SERVICE BULLETIN

Service Bulletin Number: SB-002

Subject: HIGH PRESSURE Fuel Pump Replacement

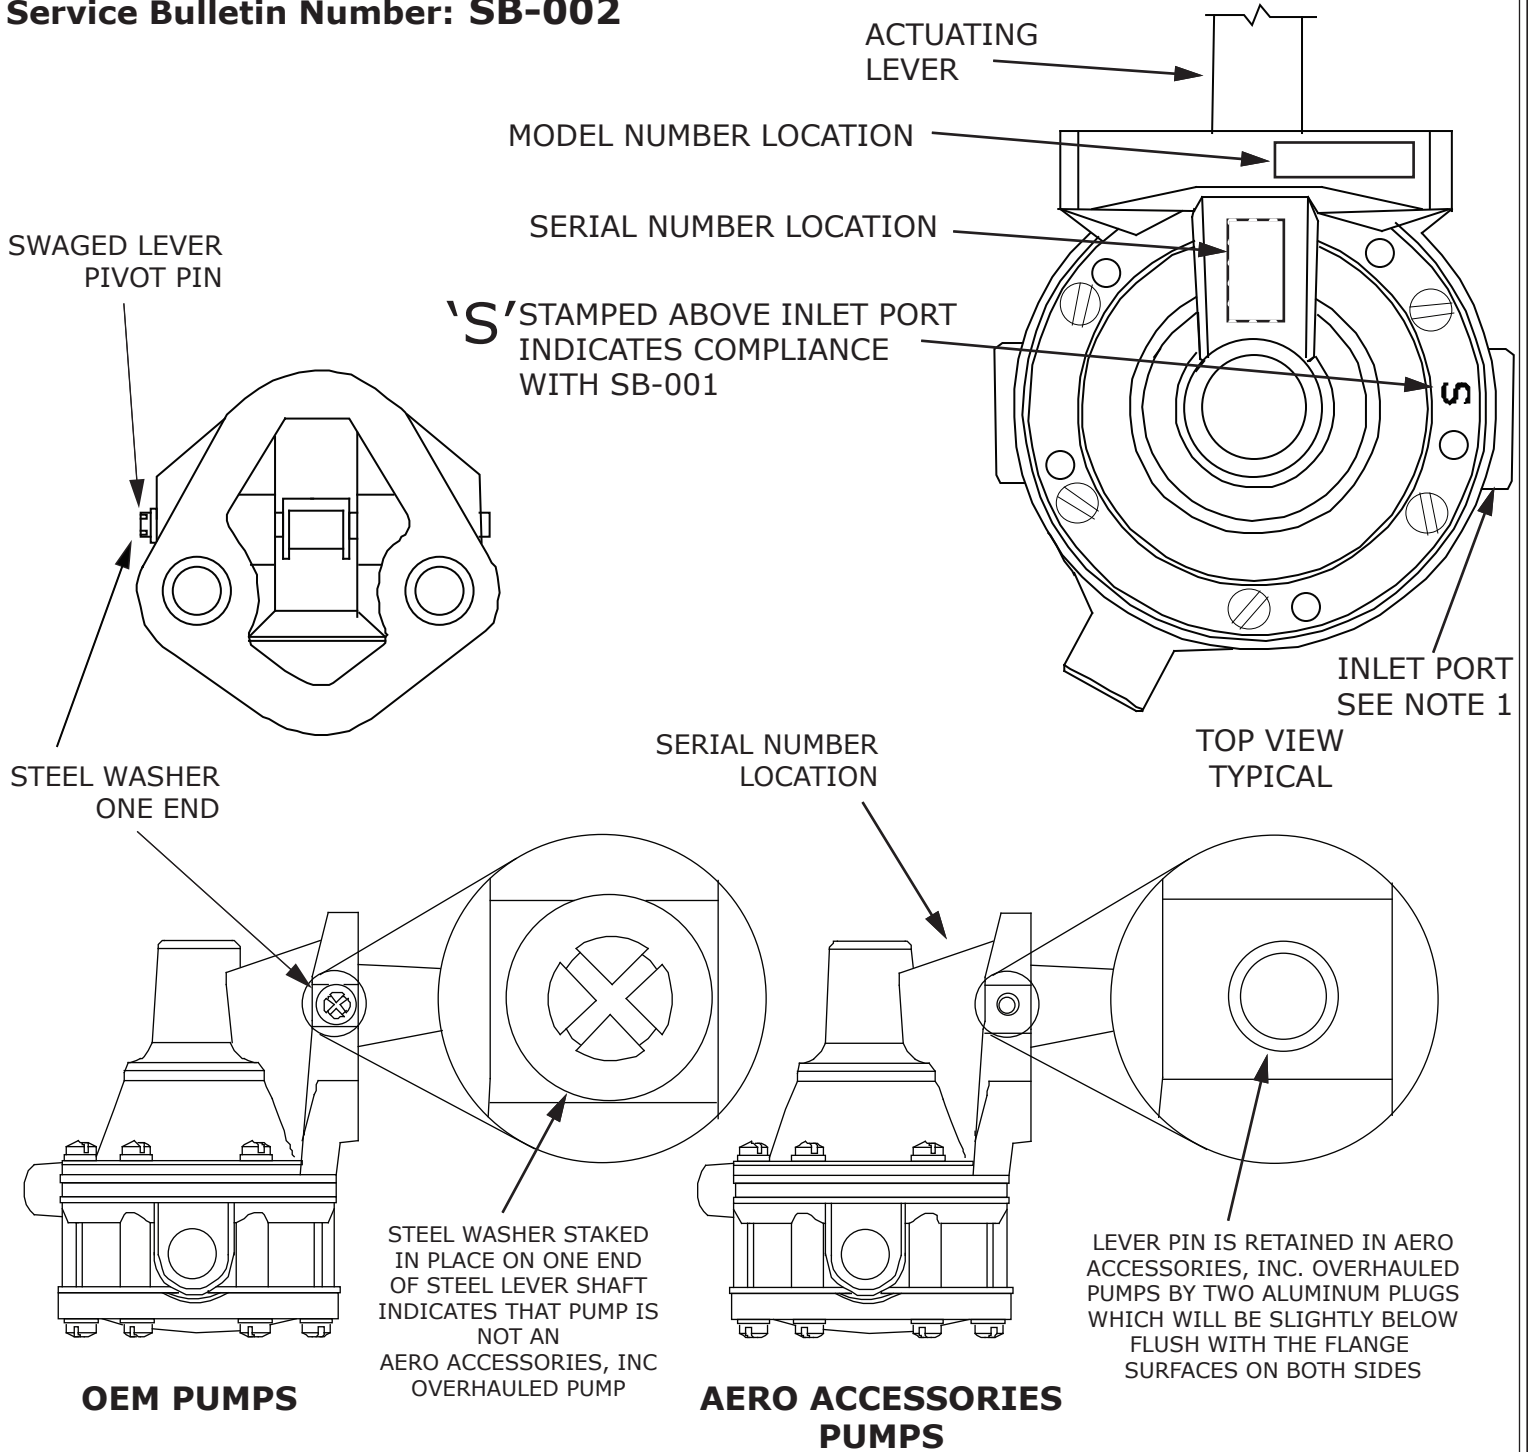
To prevent possible engine fuel starvation - all HIGH Pressure AC / Lycoming diaphragm type fuel pumps or Ray-Jay (Rotomaster) diaphragm type fuel pumps serviced or overhauled by Aero Accessories, Inc. beginning on June 18, 1991 and ending on November 24, 1992, included in the above listing of model and serial numbers, must be removed from service immediately - before further flight.

Affected units listed above which are in compliance with Service Bulletin SB-002 will be identified by the characters 'S2' stamped as indicated on Page 2 of this Service Bulletin.

Warranty: Return affected units, freight prepaid to Aero Accessories, Inc. at the address shown on the bottom of this Service Bulletin. The pumps will be processed immediately at no charge and returned freight prepaid to the sender. A one-year warranty beginning on the date of inspection / repair in accordance with this Service Bulletin.
